**IN RESPECT OF THE APPEAL AGAINST THE DECISION OF
HERTFORDSHIRE COUNTY COUNCIL FOR THE DEVELOPMENT OF
LAND AT HATFIELD AERODROME, OFF HATFIELD ROAD,
HATFIELD, HERTFORDSHIRE**

PLANNING INSPECTORATE REF: APP/M1900/W/24/3346607

NOISE

An independent review of the noise assessment for a quarry on the former Hatfield Aerodrome site detailing the impact on Housing and on a proposed Ellenbrook Country Park

Fig 2

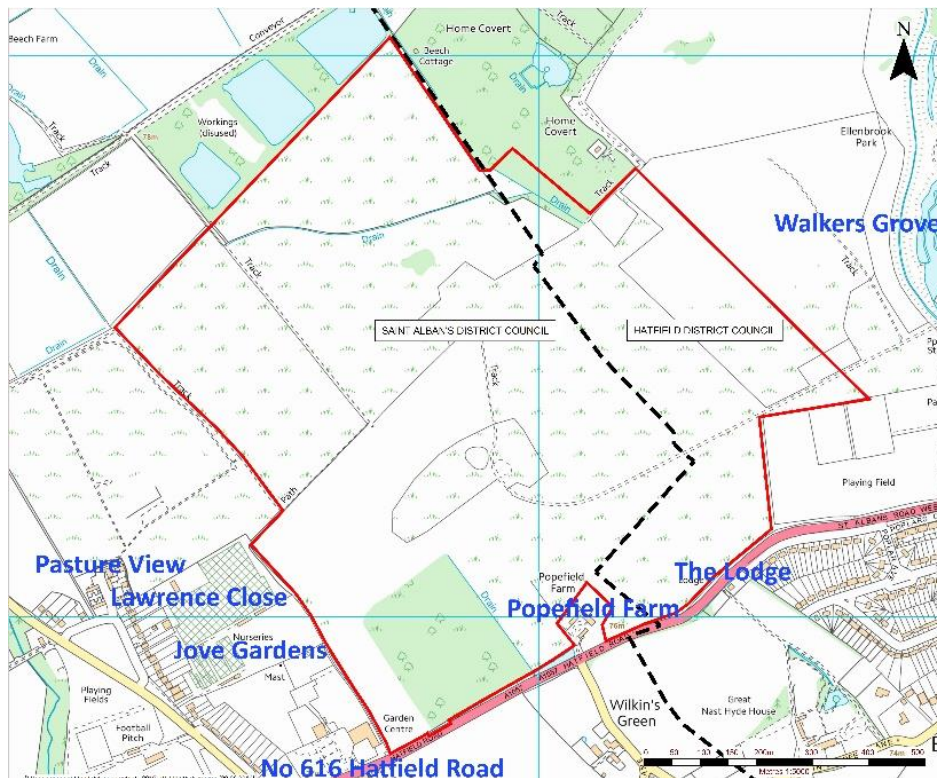
Comments on the areas affected.

This is located in the South with access from the A1057. It is surrounded by progressive phases A,B,D,F during the lifetime of the quarry. It may be impacted by three sources of noise from the Plant Site, Extraction, on-site Transport.

These two housing estates are new and have been built on the western side of the application. Lawrence Close borders directly on the perimeter fence and is only separated by a 3m bund and wooden fence.

The site's Haul Road is within 65m of Lawrence Close with HGVs-32T and dumper trucks contributing noise.

Jove Gardens is set back from the perimeter fence by 100m of open space and 650m from the plant site. It does not have its own bunds and fencing. Jove Gardens is very quiet.

Lawrence Close is a new estate and has not been included in the Applicant's Noise Assessment 10 despite it being the nearest residential site to the haul road and plant site.

The developers were aware of a potential quarry and constructed their own bund and fence (fig 4) as a defence against noise from the haul road. However, the location of the plant site is 17 degrees N therefore the bund and fence will have little impact on plant noise.

Fig 6

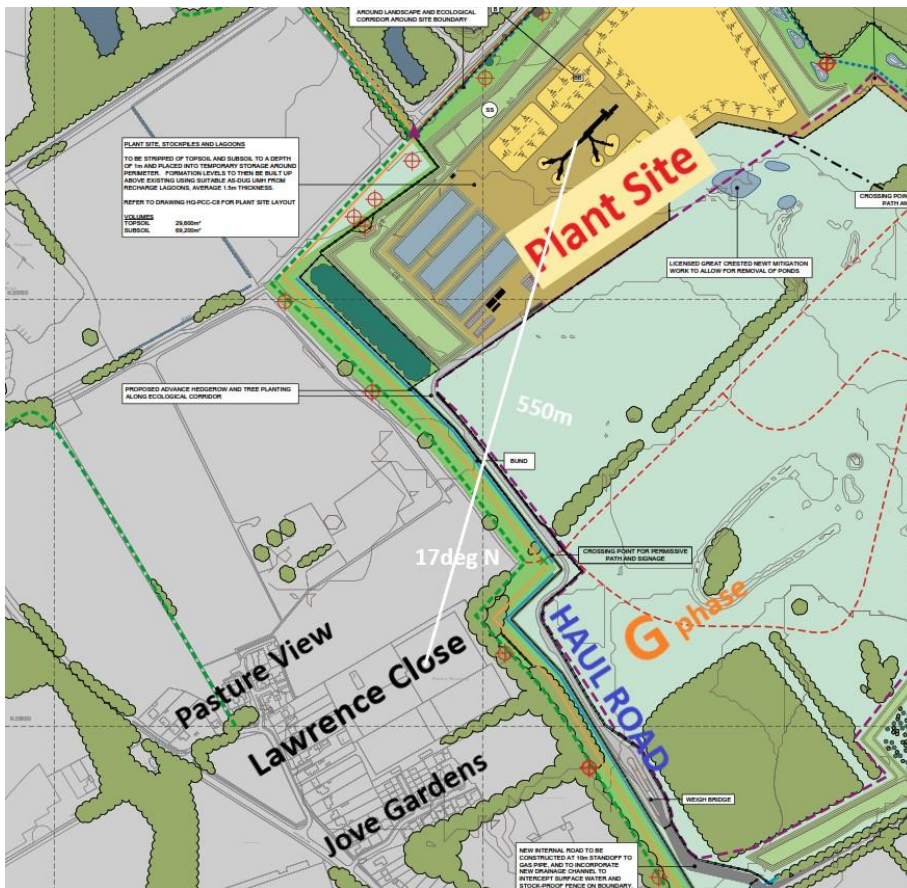
Our site survey showed it to be very quiet, it is also the closest residential area to the quarry site. To mitigate any potential noise the developers constructed a bund with wooden fence on top.

Any noise impact will come from the Haul Road, the Plant Site, and later in the development Phase G

Fig 7

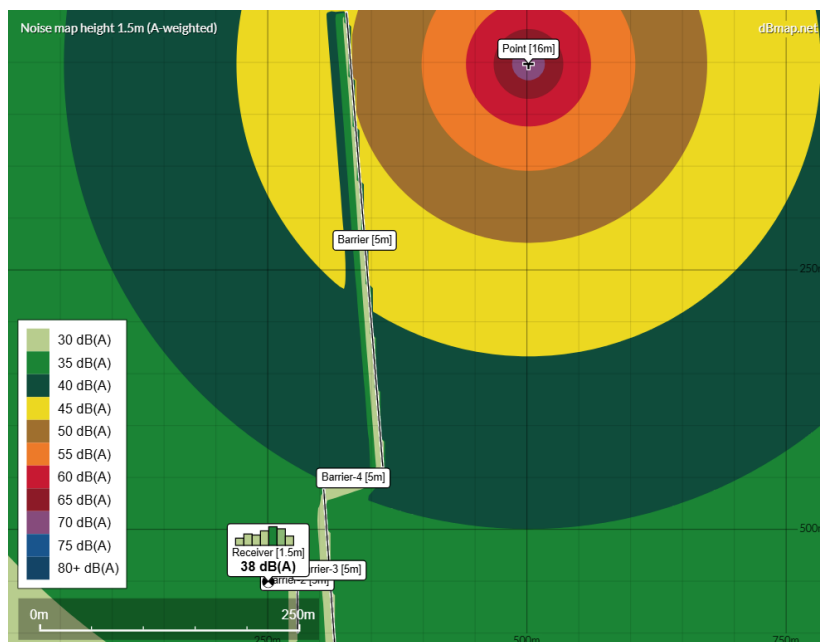
The plant site lies 550m to the North at 17°N. At 16m tall the plant emits 108dB of noise during the day over soft ground.

The simulation below includes the quarry's 5m bunds running N-S and the local estate's bund but due to the 17deg N angle, this bund becomes ineffective.

The result is **38dB(A)** at the receiver

Fig 8

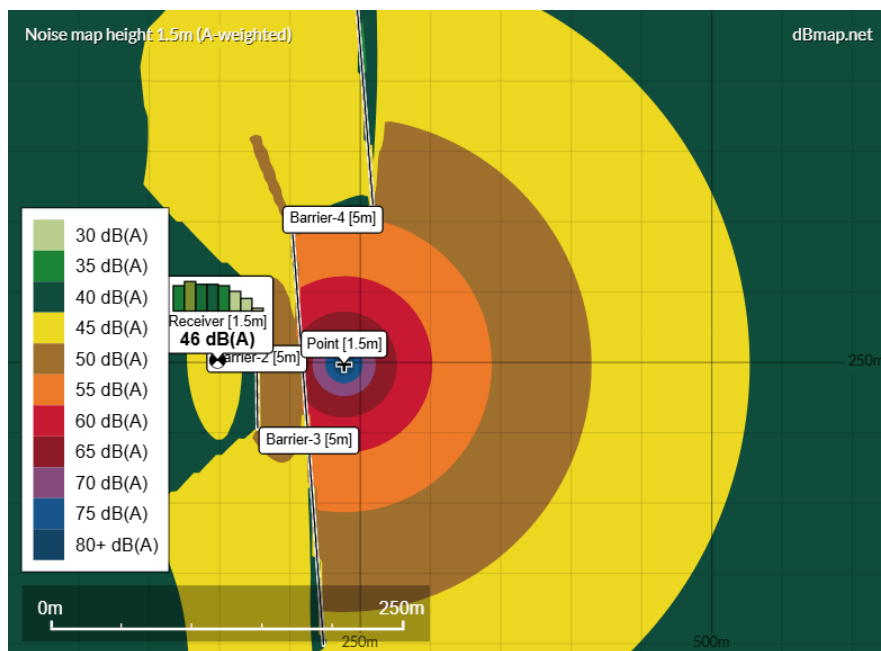
The haul road lies to the east of the Estate taking HGV and Articulated dump trucks during the day. Both bunds are effective in reducing the noise, but a simulation result shows **46dB(A)** at the receiver(Estate).

The combined noise from the Plant and the Haul road is: $38\text{dB(A)} + 46\text{dB(A)} = \mathbf{47\text{dB(A)}}$

Fig 9

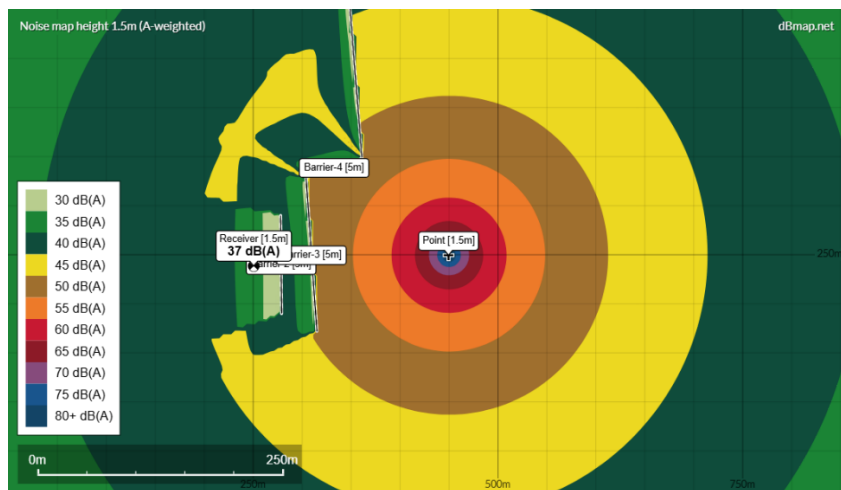
Simulation of **phase G**, 200m to the East will produces **37dB(A)**

$$38\text{dB(A)} + 46\text{dB(A)} + 37\text{dB(A)} = \mathbf{47\text{dB(A)}}$$

- The bunds and fence built by the developer will provide very little noise protection
- We cannot verify the baseline or ambient, but it could be as low as 33 dB therefore in this case the combined noise sources could add **14dB(A)** or **4dB(A)** above the guidance value.
- This combined noise level becomes **MAJOR** over the lifetime of the quarry

Fig 10

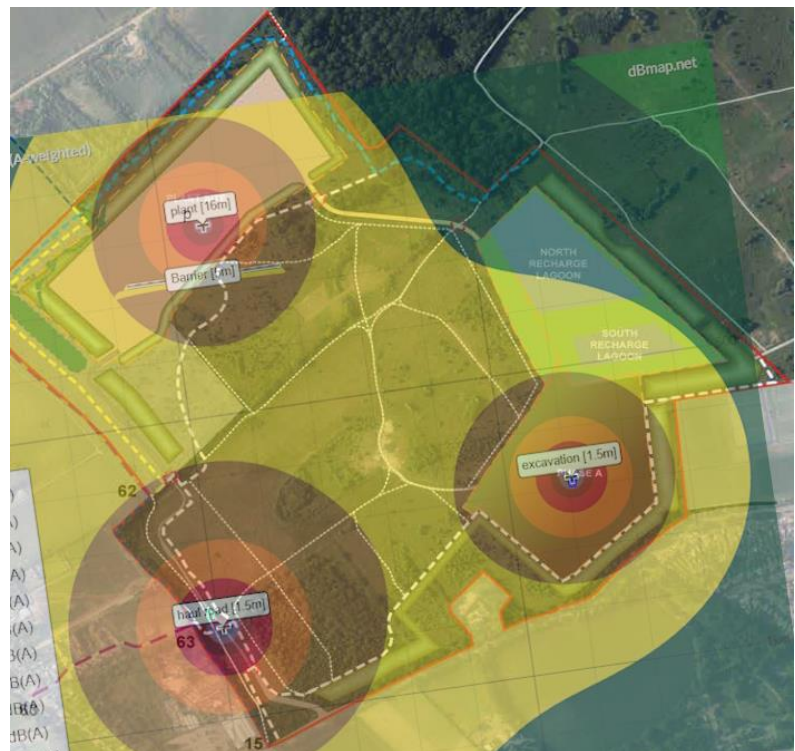
Fig 10 shows a simulation of the three sources of noise on the park.

Plant Site	Excavation	Haul road
55dB(A) max	52dB(A) max	63dB(A) max
49dB(A) min	49dB(A) min	59dB(A) min
northern walking route	southern walking route	Point

- The whole park is subject to **49dB(A)** of noise (yellow).
- Park users will be impacted by excessive noise on the proposed routes (dotted) as detailed on the Public Access Strategy June 2023, when they pass any of the three sources. Half of the walkways will be over the 55dB(A) threshold and assuming a base level of 33dB(A) all will be over the 10dB(A) mineral guidance for noise.
- An extra bund on the southern border of the Plant site, would make no difference to the Park itself but would reduce pathway noise to 45dB(A), providing the path was within 25m of the bund.
- We cannot verify the baseline or ambient, but it could be as low as 33 dB therefore in this case the combined noise sources will add **16dB(A)** or **6dB(A)** above the guidance value.

Fig 10a

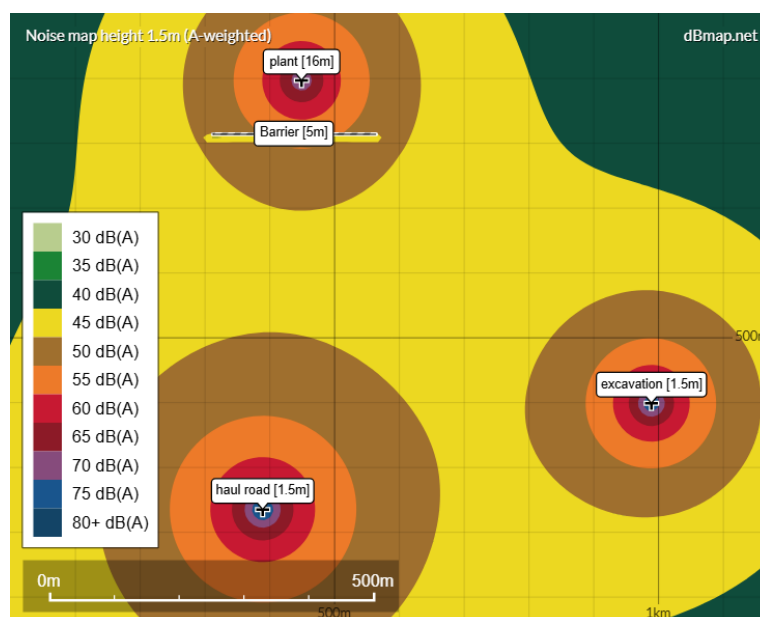
Figure 10a shows the simulation sources on the Park.

13.Theoretical noise with distance

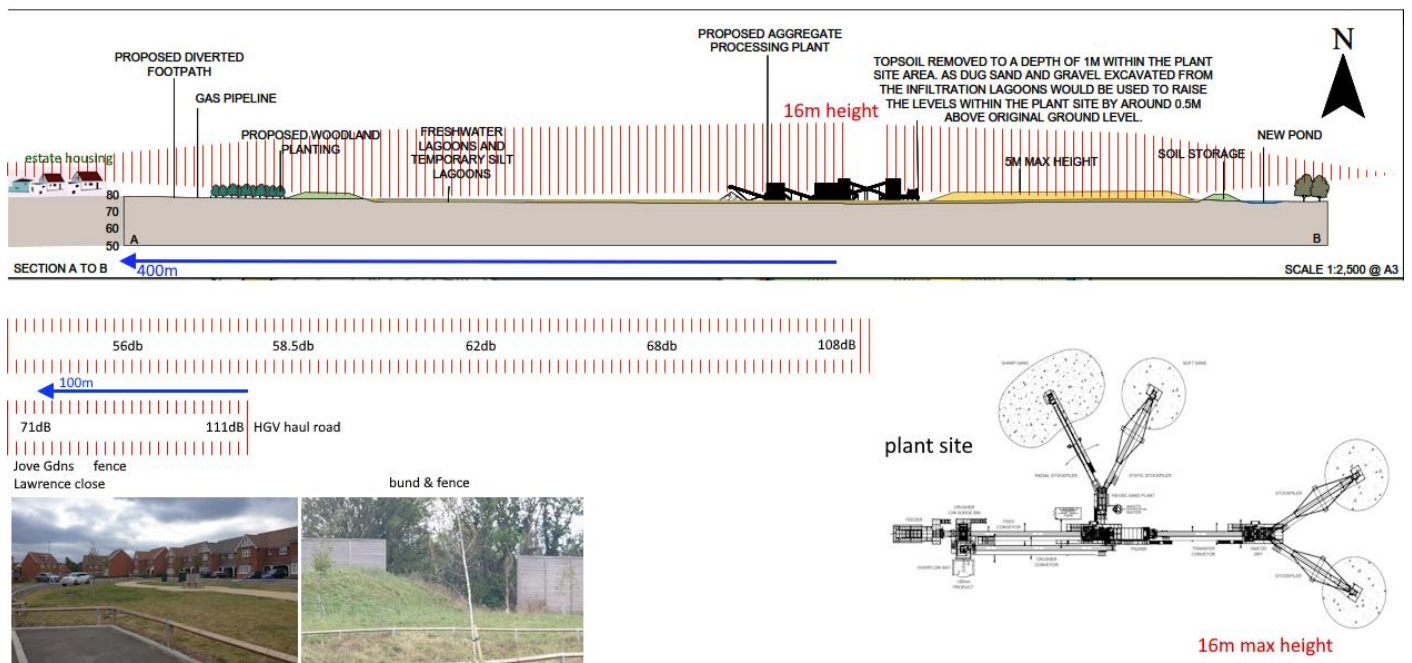
- The graphics above illustrate how the noise will travel over the bunds and impact the residential areas of Jove Gardens and Lawrence Close
